**In the matter** of Ashbourne

**MEMORANDUM OF COUNSEL ON BEHALF OF MATAMATA DEVELOPMENT  
LIMITED**

To: Expert Consenting Panel - Ashbourne  
From: Dean Morris (Maven Waikato Limited)  
Subject: Ashbourne, Matamata –Minute 16; Stormwater  
Date: 27<sup>th</sup> February 2026

To: Expert Consenting Panel – Ashbourne  
 From: Fraser McNutt / Steph Wilson – Barker & Associates Limited  
 Date: 27 February 2026  
 Re: Planning response to WWLA memorandum in relation to consent conditions

Figure 2: Post Development Flood Overview

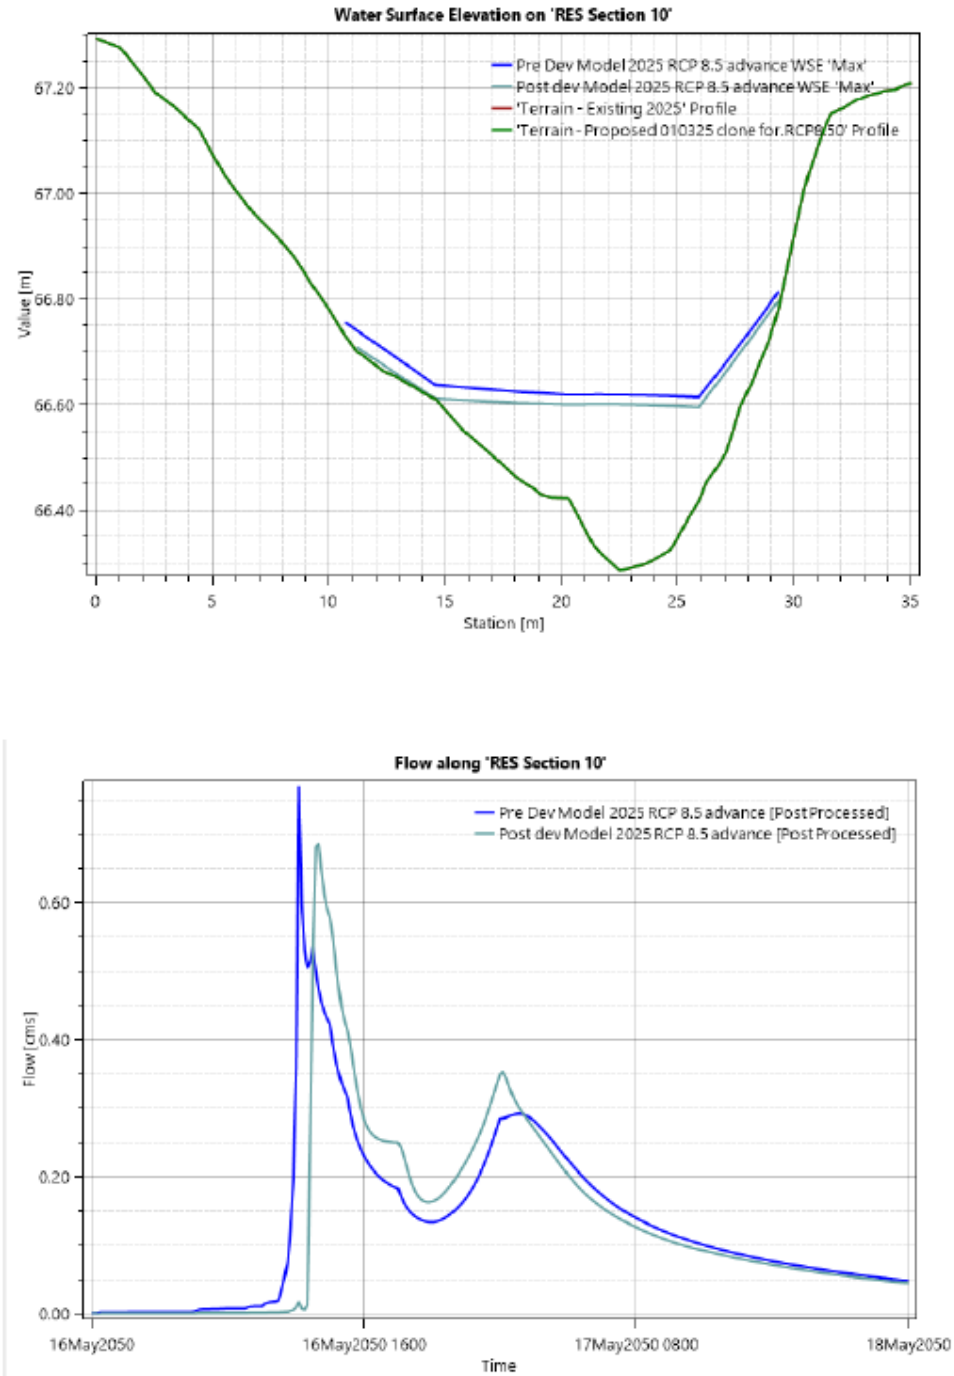
As part of the sensitivity checking process that's required through the Stormwater management modelling it was found that we are improving flooding within the Eldonwood Precinct. This modelling is scenario based on full blockage of the Primary Reticulation Network and no allowances for Soakage within Basin A. This is an unrealistic and highly conservative scenario that exceeds relevant standards but is effectively what has been asked for by Mr Williamson.

In such a scenario Basin A will fill and has an overflow / tipping point flowing to the north as a small overland flow. Basin A was specifically located in this location as this overland flow already exists in the predevelopment state. The predevelopment flow in the absence of basin A is some 800l/s. Post development with the storage available the flow is reduced to some 700l/s.

Essentially, from this sensitivity model the results show that the level through RES Section 10 was reduced (as per screenshot below). This concludes the basin has a positive impact even with zero soakage verses the existing scenario storm event of 100-year RCP 8.5 ie it not only reduces the flow to the north but also mitigates the effects of climate change on properties to the north. See below screenshots as shown in SMP.

Title  
**PROPOSED  
 SW OVERALL  
 CATCHMENT PLAN**

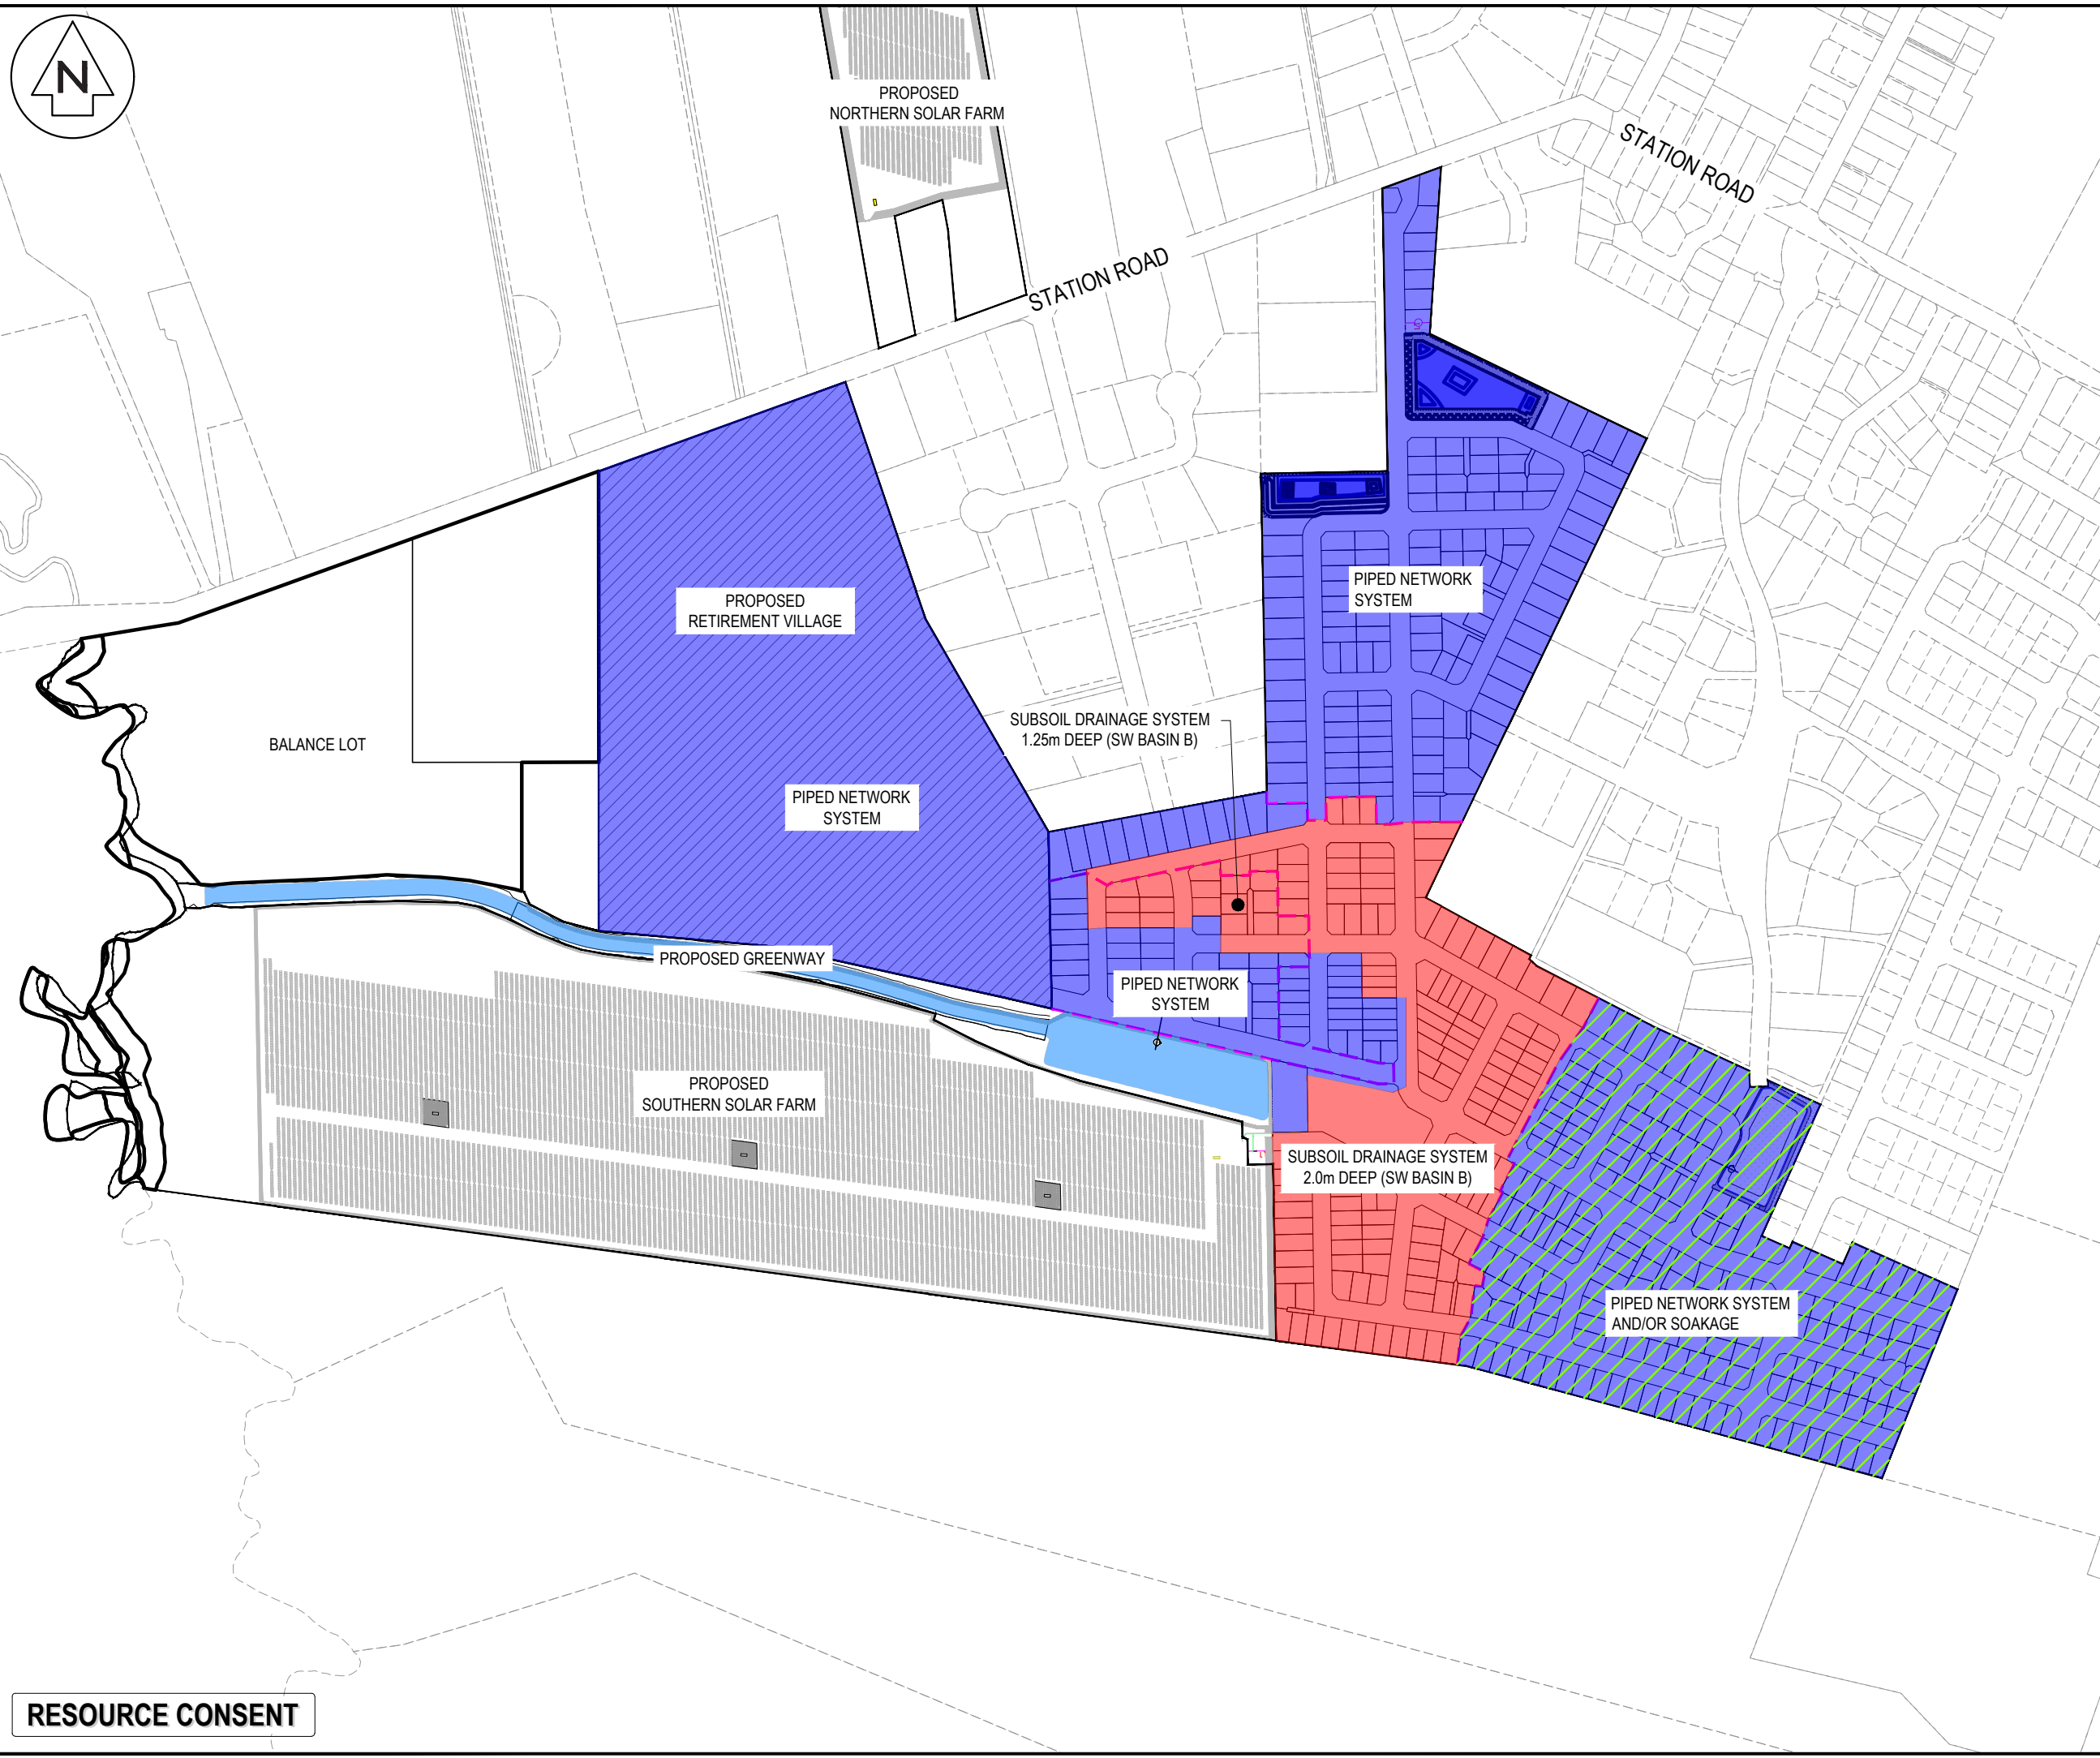
The required design storage volume for the 100-year, 24-hour nested storm event (including climate change adjustments) has been determined as set out in Table 1. The confirmed available storage within Basin A, including volume and associated freeboard allowance (refer Tables 2, 3 and 4), provides sufficient capacity to contain the full design event volume.

The infiltration component has been modelled using a deliberately conservative rate of 36.03mm/hr, substantially lower than site-tested values, and is therefore treated as additional redundancy rather than a prerequisite for compliance. Even under materially reduced infiltration assumptions, the basin retains sufficient hydraulic storage capacity to meet the RITS requirements.
